HEDSTROM POULSBO RESIDENCE

COVAL HOMES PLAN - ALDERWOOD

Reviewed for code compliance
with IRC 2015
Kitsap County Building Department
GShapiro@co.kitsap.wa.us
05/20/2020

Roof Framing
Plan

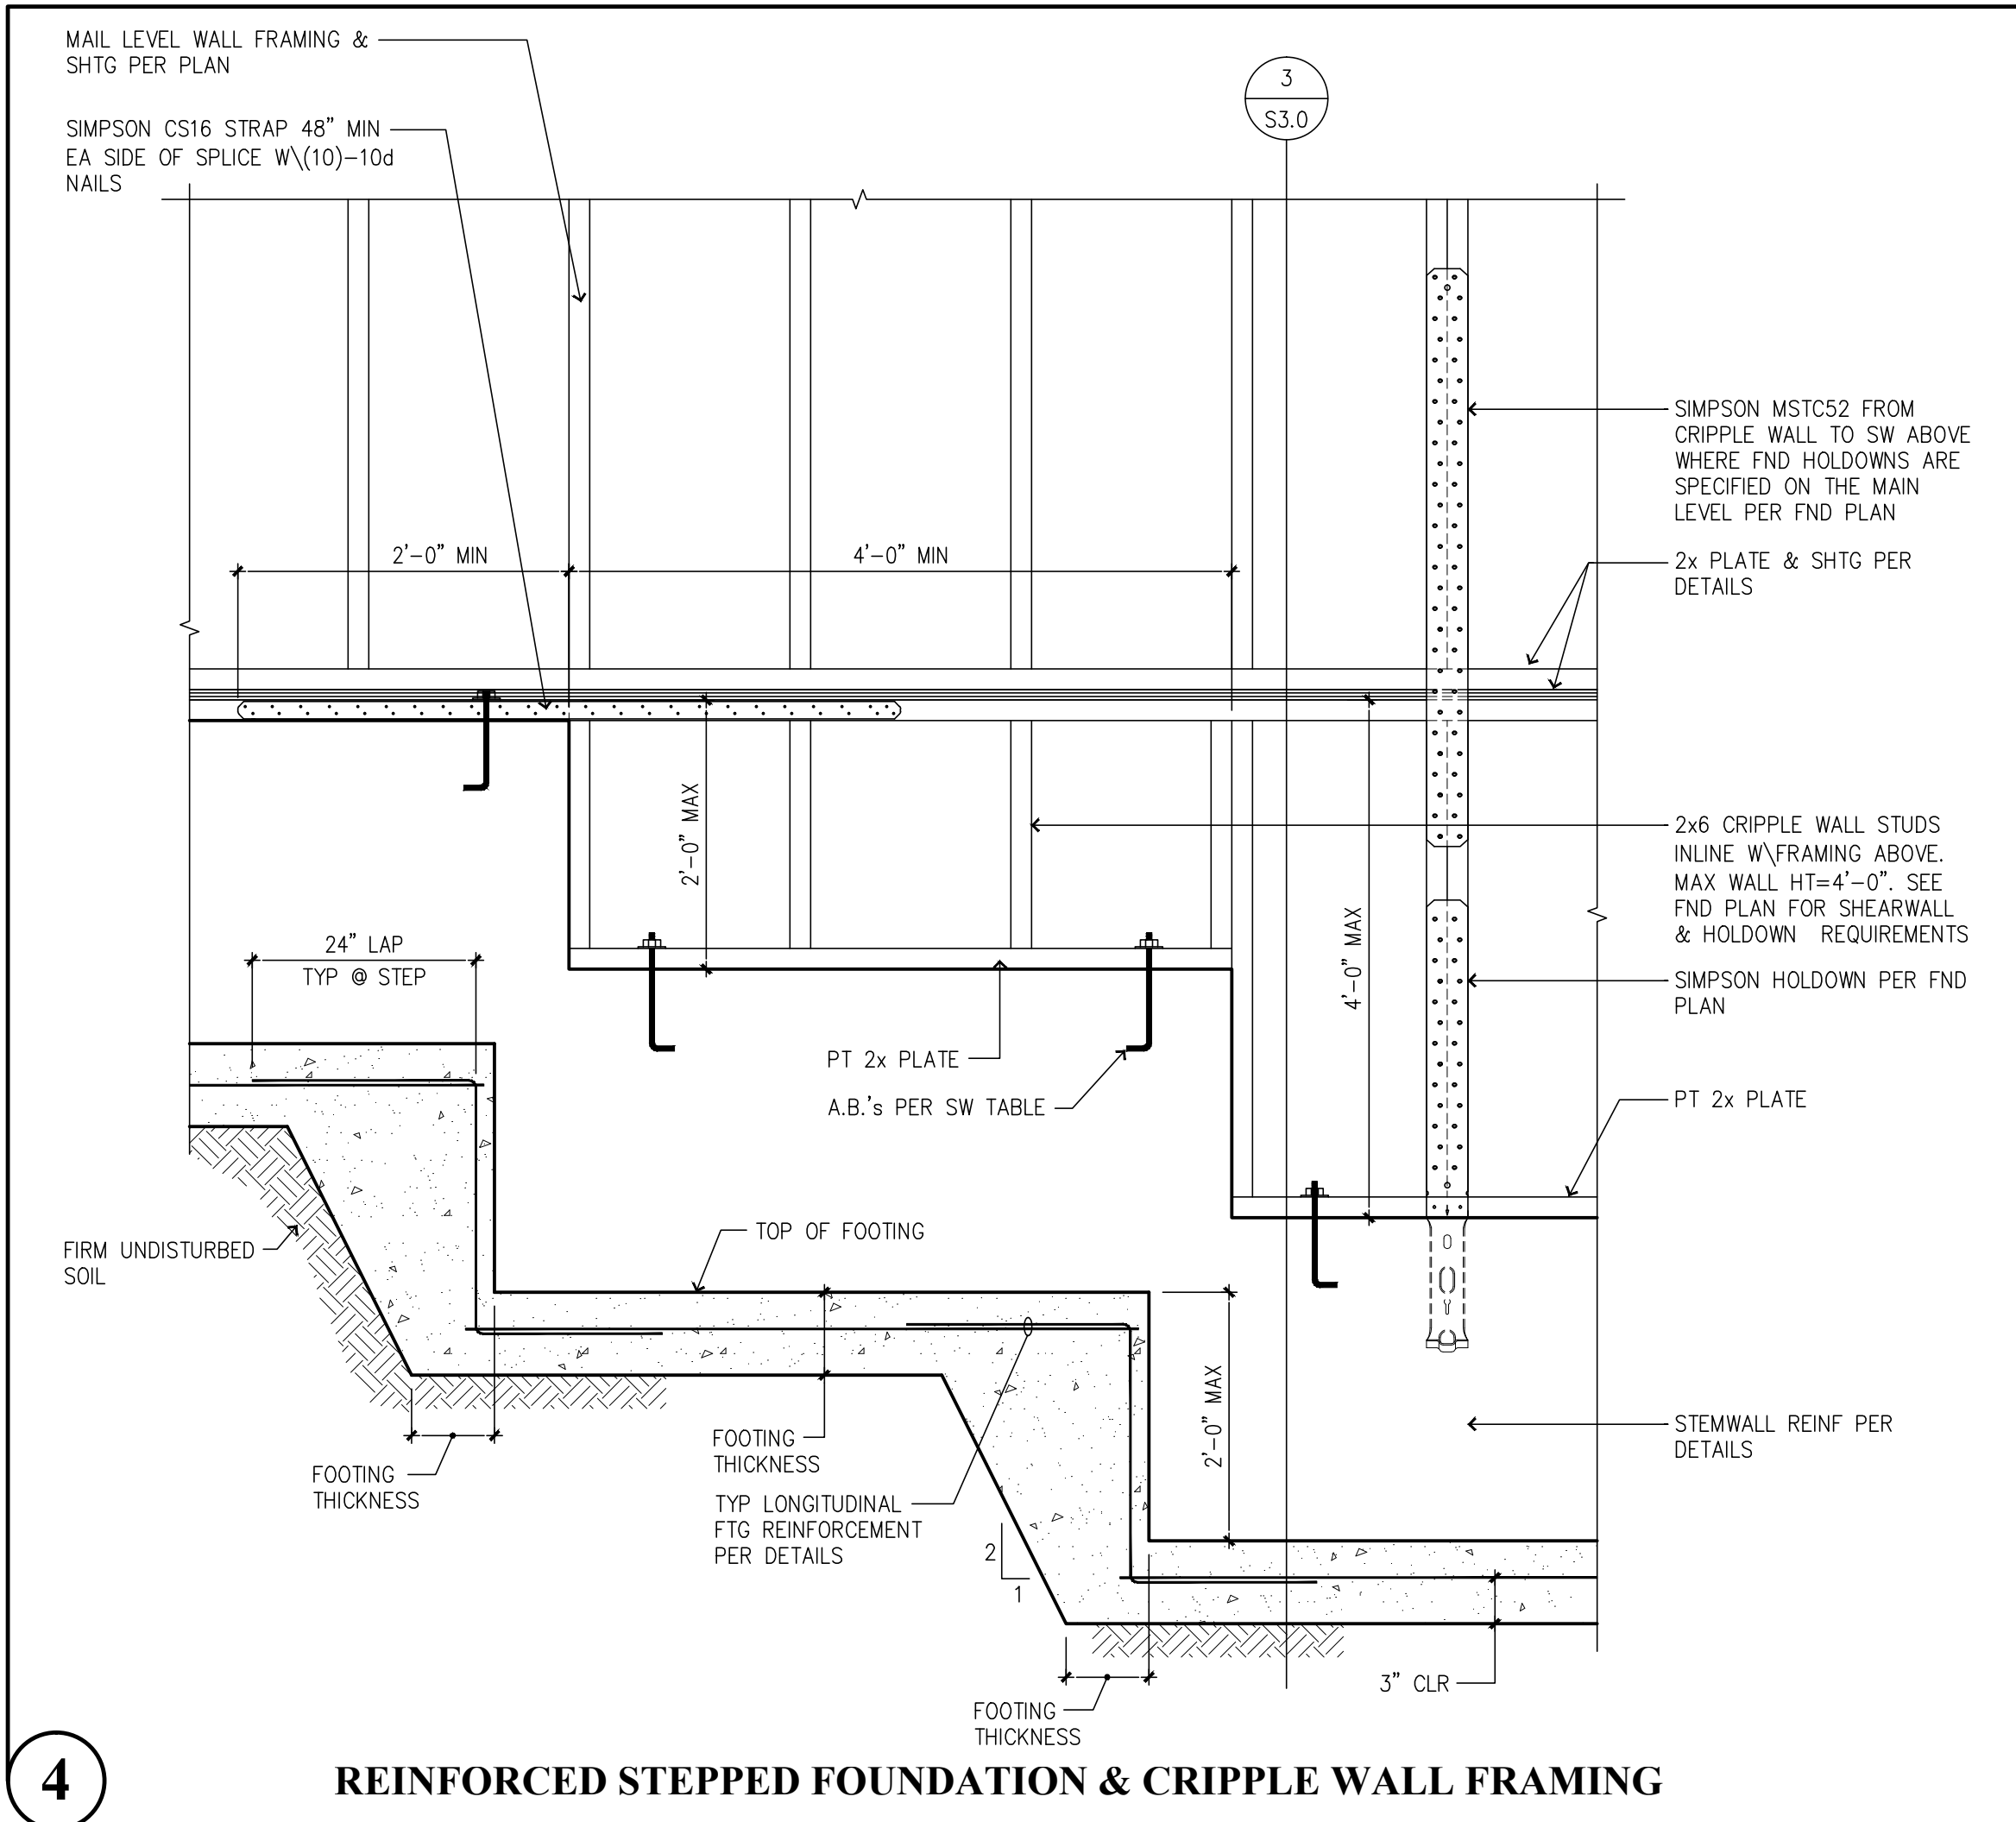
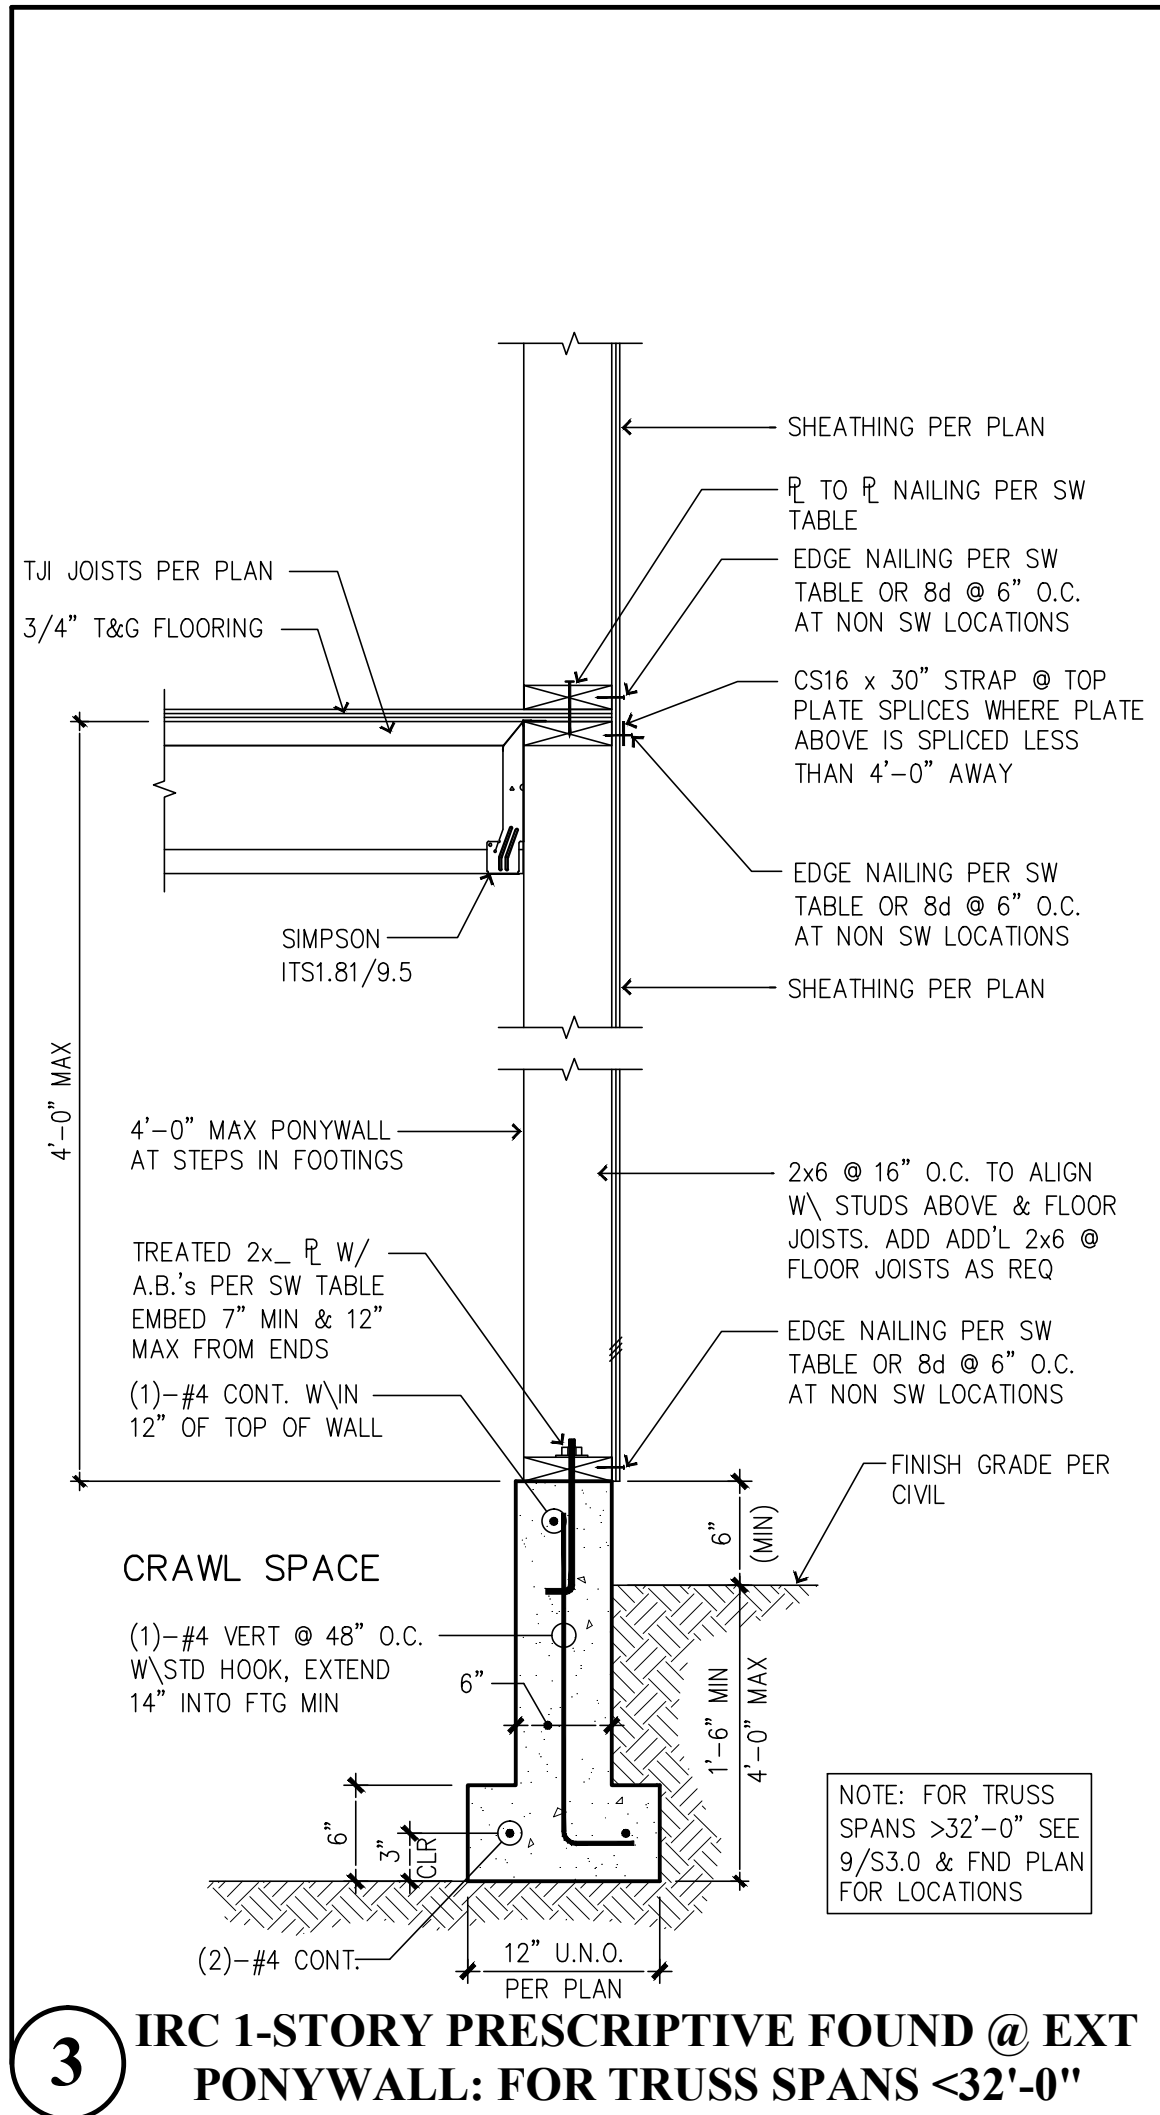
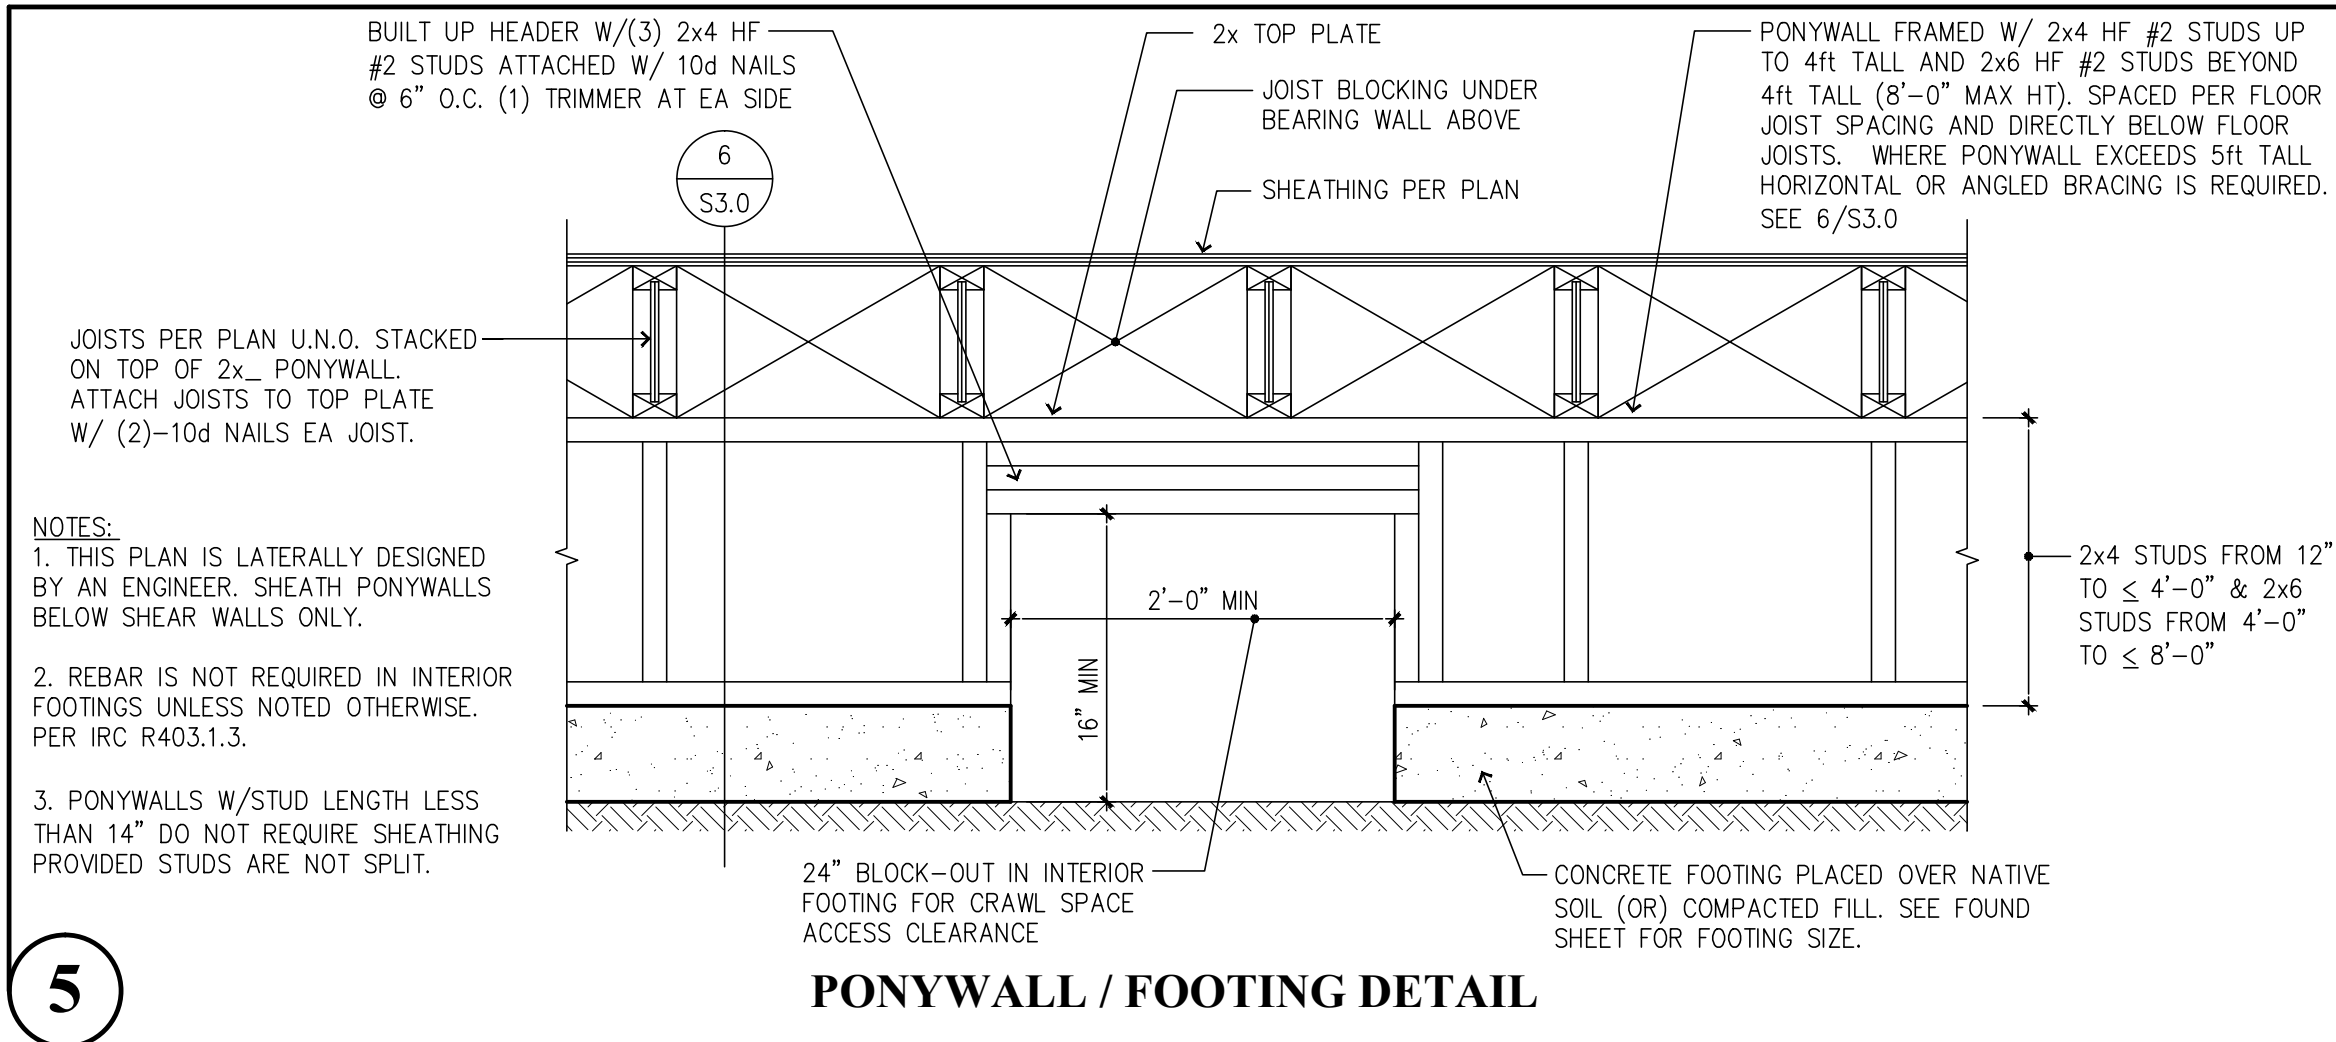
Full manufactured truss engineering shall be available on-site at framing inspection
